Re: FortisBC Inc. (FBC)

2021 Long-Term Electric Resource Plan (LTERP) and Long-Term Demand-Side Management Plan (LT DSM Plan) (Application)

Response to the Commercial Energy Consumers Association of British Columbia (CEC) Information Request (IR) No. 1

Figure 9-3: Winter Capacity Load-Resource Balance after DSM and EV Charging Shifting

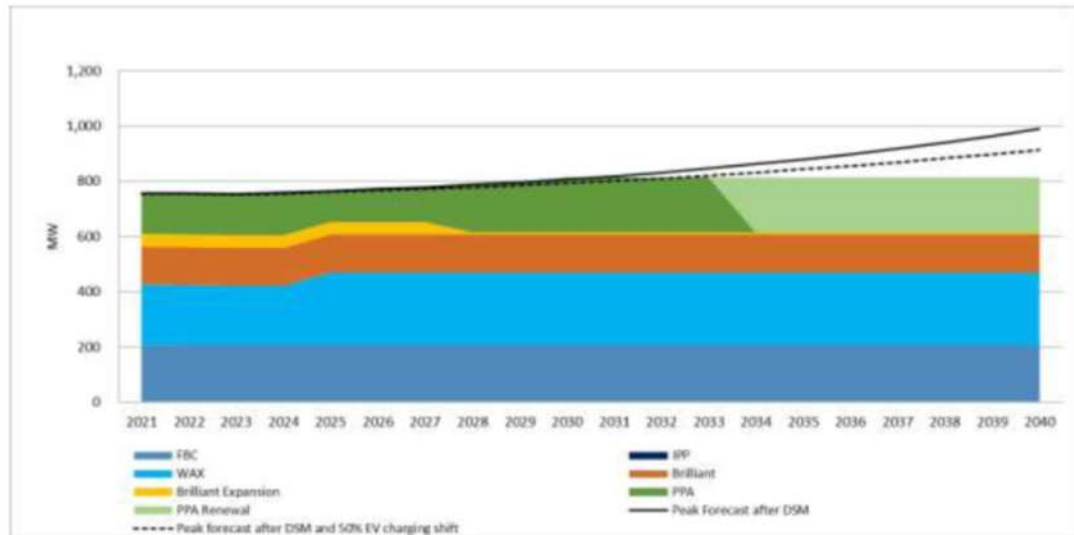
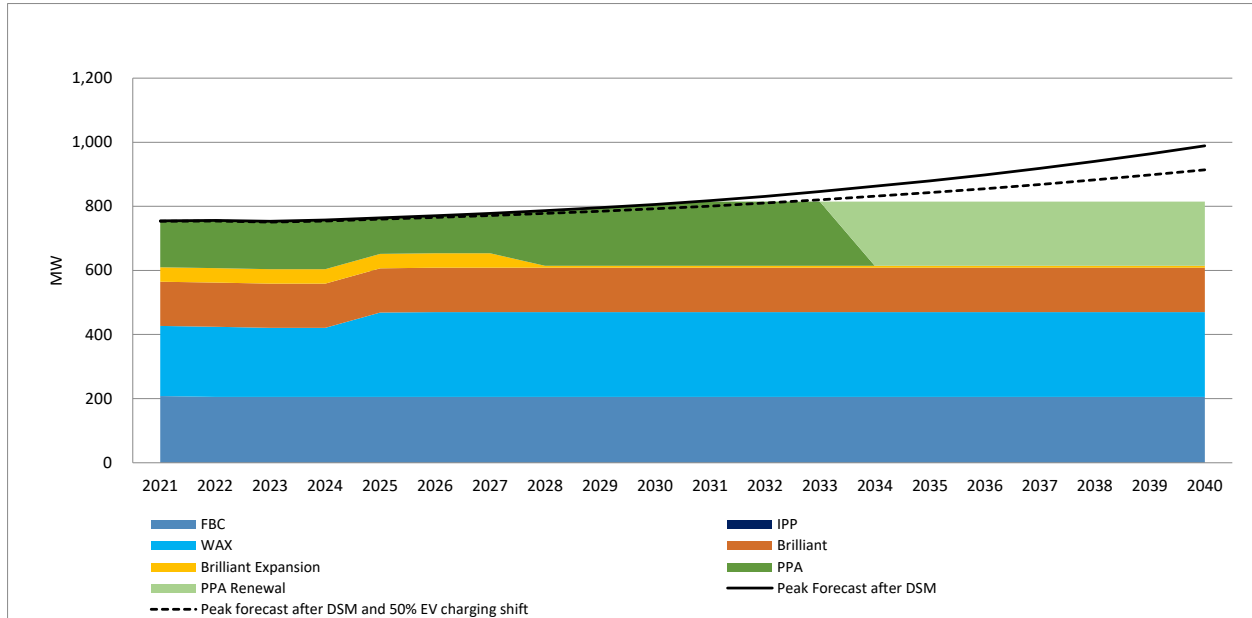
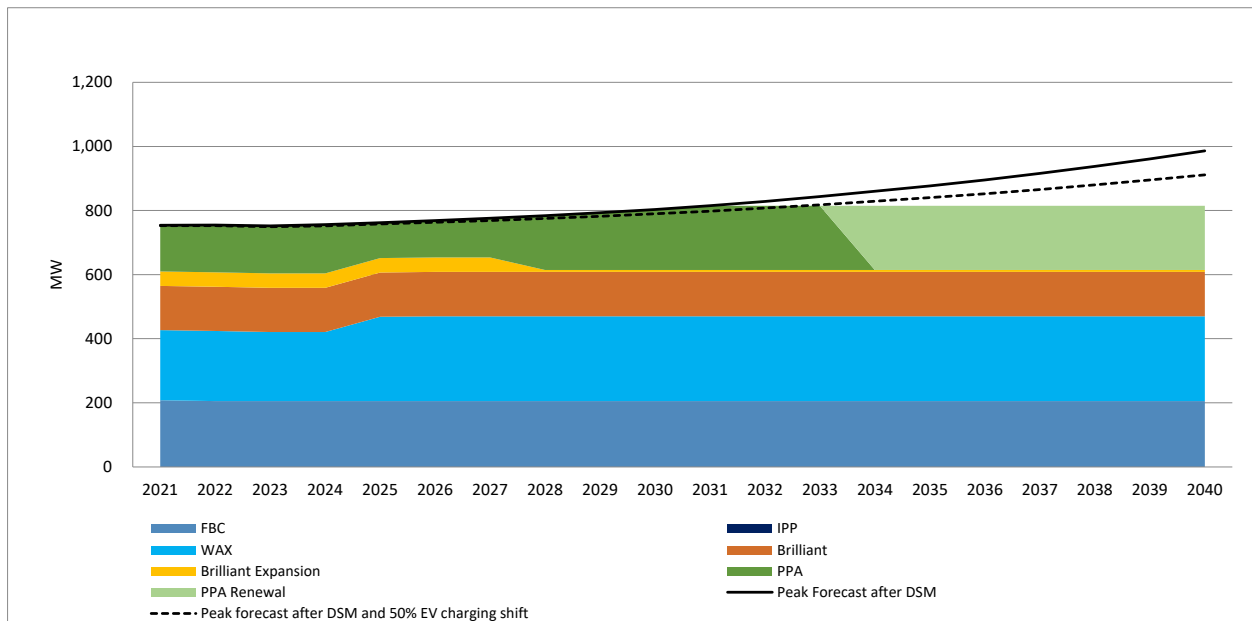
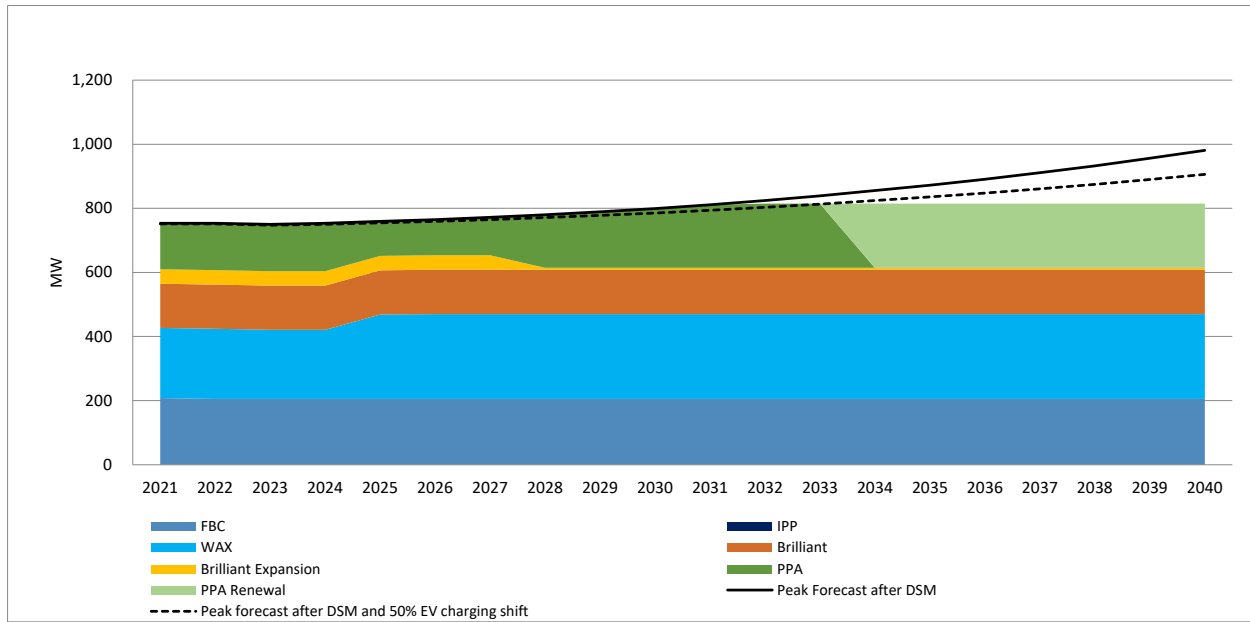
4 Figure 9-3 for each of the alternative DSM options with higher incentives and

Figure 11-1: Portfolios with Varying DSM Levels

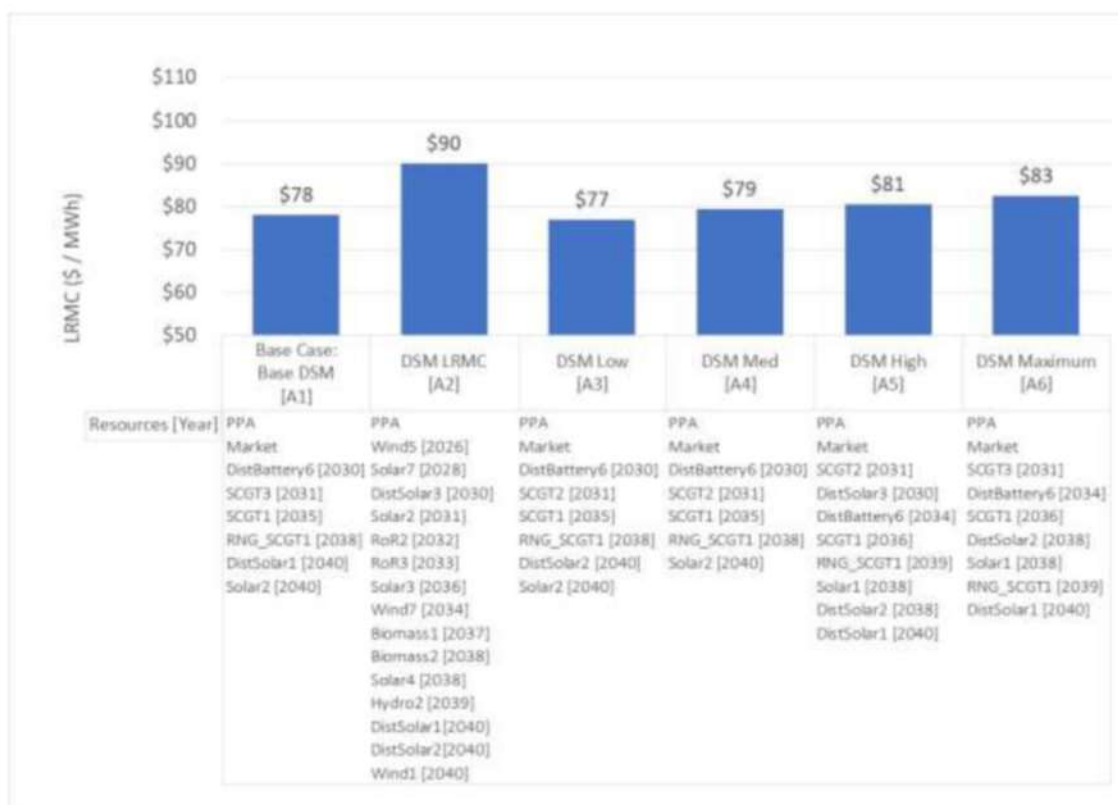
2
3 51.1 Please discuss the costs for the renewable wind and solar energy being used in
4 these portfolios, along with battery technology for assuring capacity in the daily
5 delivery of the energy when it is needed, relative to the potential progression over
6 time for the decline of the costs for these alternatives.

- 1 significant generator cost declines over the planning horizon relate to wind, solar, and battery
- 2 storage.

Figure 11-4: Portfolios based on Load Scenarios

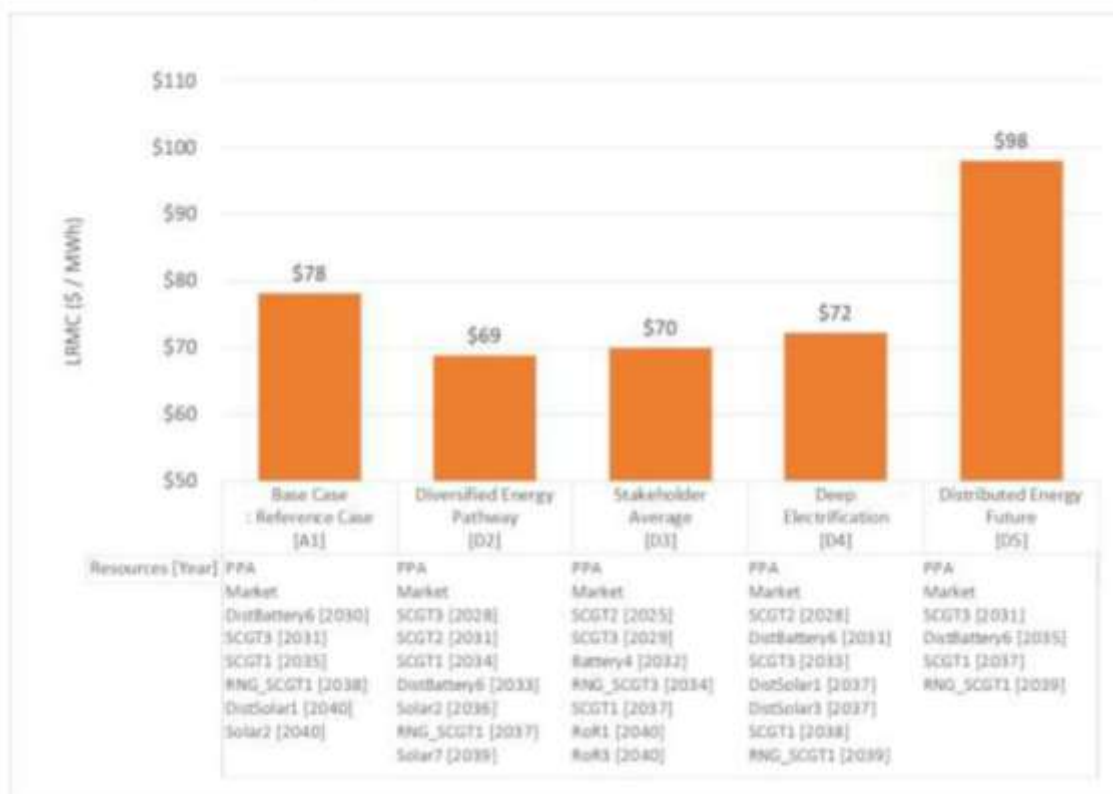
2
3 54.1 Please comment on the SCGT3 options and whether or not they could be capable
4 of accepting synthetic methane in the future as a clean version and how this gas
5 supply option might become a significant reality with the evolution of the hydrogen
6 strategy and the carbon taxing environment.

Figure 11-5: Portfolios based on Different Percentages of EV Charging Shifting

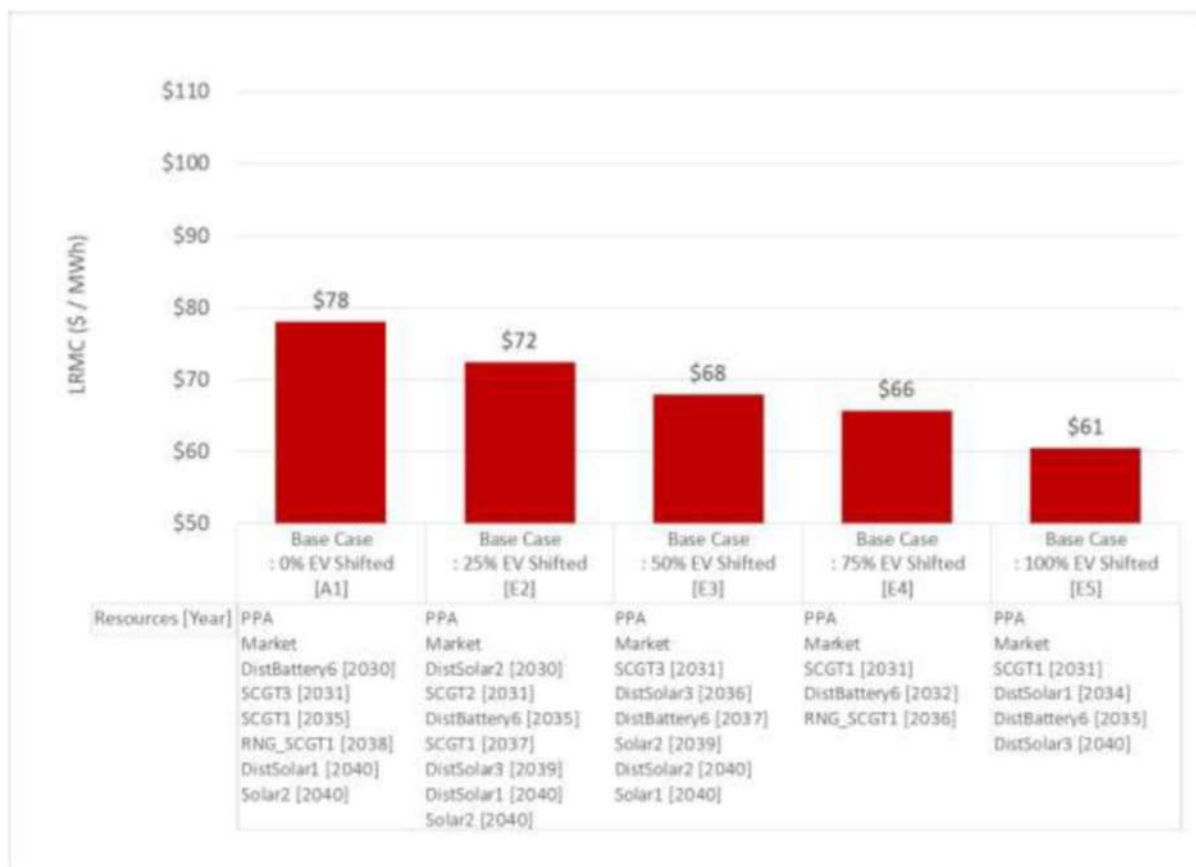
2
3 55.1 Please comment on the requirements for EV charging shifting as the percentage
4 shifts to 100% favourable timing for charging, particularly the specific timing to
5 avoid capacity peaks both for the generation supply and for the local electrical
6 infrastructure system.

The conclusion to be drawn from Figure 11-5 is that an EV program designed to encourage and shift charging from evening peak hours when customers return from work to non-peak times, such as the middle of the night, will help to improve the efficiency of the system and therefore decrease the unit cost of incremental energy.

Figure 11-7: Portfolios Considered for Preferred Portfolios

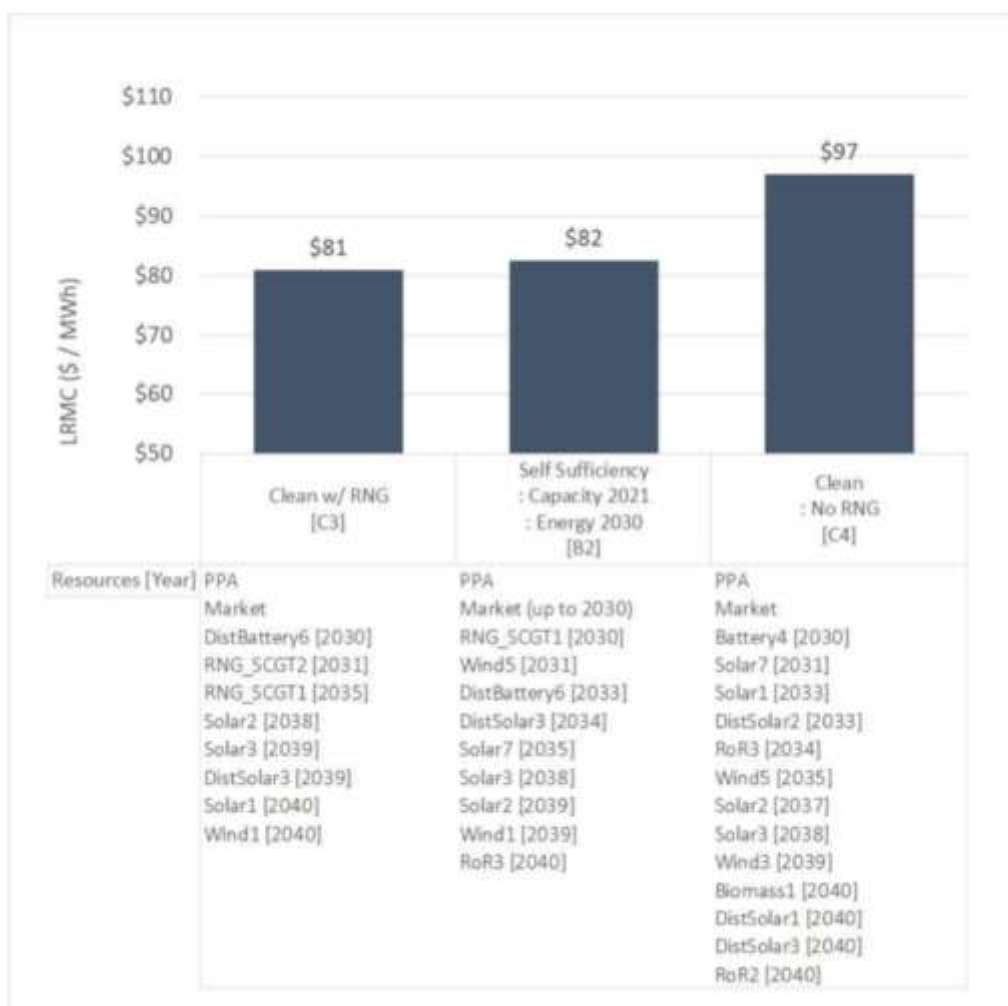
2
3 56.1 Please comment on why FBC would include C4 as a preferred option when it is so
4 clearly expensive beyond repair.

However, FBC recognizes that having an EV charging mitigation program in place does change the capacity-related requirements as shown in Figure 11-5. FBC expects to include an EV charging mitigation program for the base/preferred portfolio as part of the planned assessment work in the next few years related to determining resource options, in case they are required, ahead of submission of the next LTERP.
